TITLE - DOOR AUTOMATION

DWG NO - NTPL- 300-PM-01

PRODUCT - MOTORIZED ROLLING SHUTTER
PROJECT NO - NTPL- 300 | REVISION - 01
SITE LOCATION-GUJARAT | WEIGHT - 634
MATERIAL - G.I+MS | QTY - 01 NOS
IF ANY QUERIES CONTACT - Design@nihva.com
ALL DIMENSIONS ARE IN 'MM' | A2
PROJECTION METHOD | SCALE :
SHEET 1 OF 1

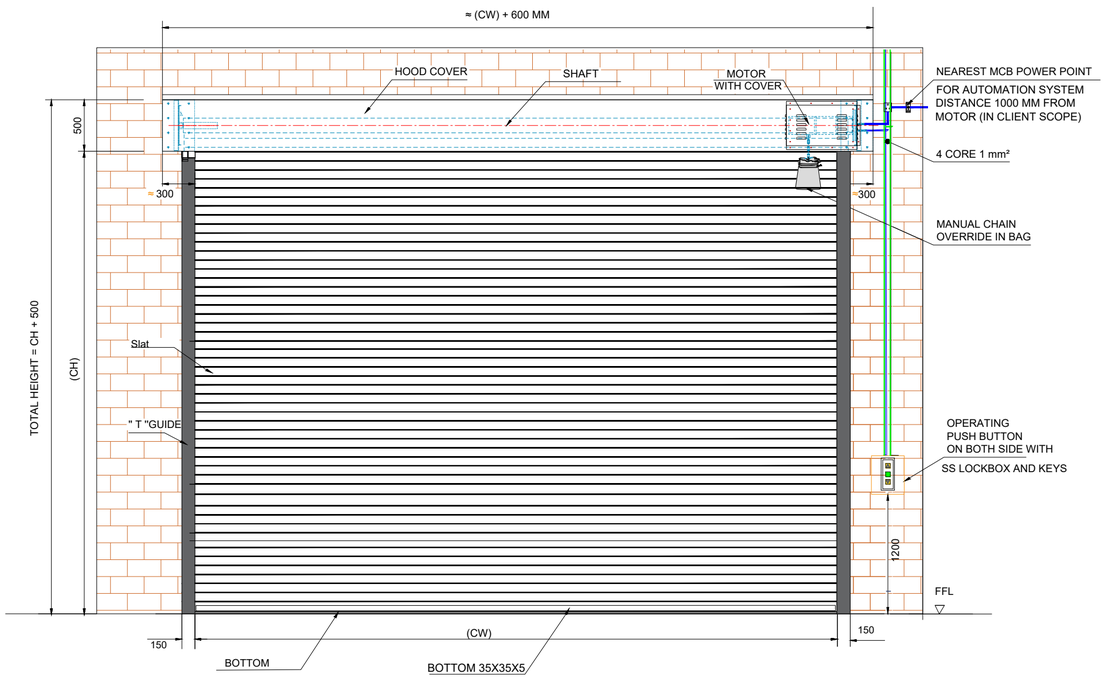
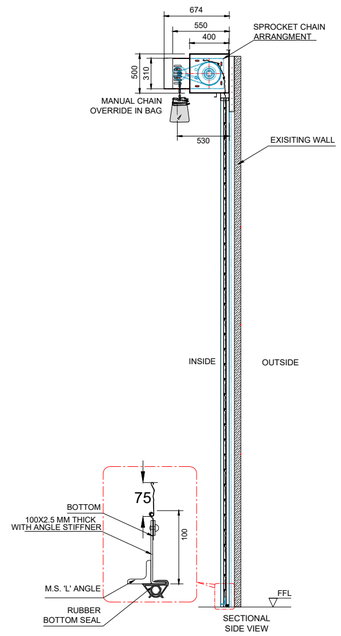
RIVISION.	DATE
REV 01 : SLAT THICKNESS CHANGE 1MM TO 1.2MM BOTTOM PLATE THICKNESS CHANGE 2.5MM TO 3.15MM ANGLE STIFFENER CHANGE 35X35X3 MM TO 35X35X5 MM	03-12-2025

SR.	SPECIFICATION	DETAILS
1.	DESCRIPTION & DRIVE	MOTORIZED ROLLING SHUTTER (INDIRECT DRIVE)
2.	LOCATION AREA	INSIDE AREA / OUTSIDE AREA
3.	MOUNTING SURFACE	SIDE BRACKETS: OPTIONAL = ON CONCRETE/STEEL&SIDE
4.	SLAT	GI SLAT- 1.2MM THICK (75 MM WIDTH)
5.	BOTTOM PROFILE	MS PLATE100 x 3.15 MM THICK WITH ANGLE 35X35X5 MM .
6.	GUIDE PROFILE	M.S." T " SHAPED PROFILE 100X150X3 MM THICK.
7.	HOOD COVER & MOTOR COVER	MADE OF GI SHEET THICKNESS 0.9 MM.
8.	SURFACE FINISH	POWDER COATING DFT 90 TO 130 MICRONS
9.	PUSH BOTTON	3 WAY PUSH BUTTON ON SINGLE SIDE
